# ADA Curb Ramp New Construction Inspection Form (Perpendicular)

NW TIMERIC DR

24953

NW TUREL DR

## PERPENDICULAR RAMP (PR)

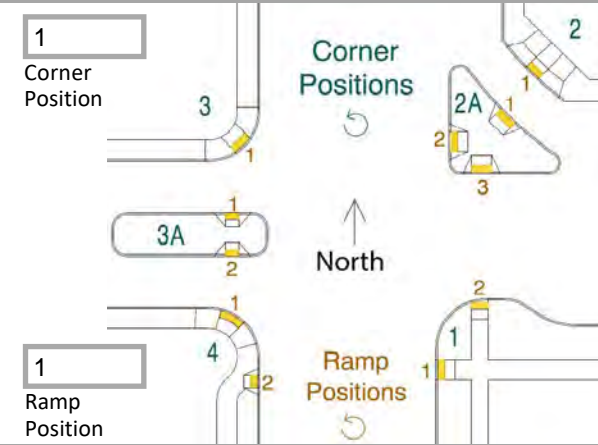
Counter Slope (+/-) \*2

5.8

☒

Slope Y

2.3

☒
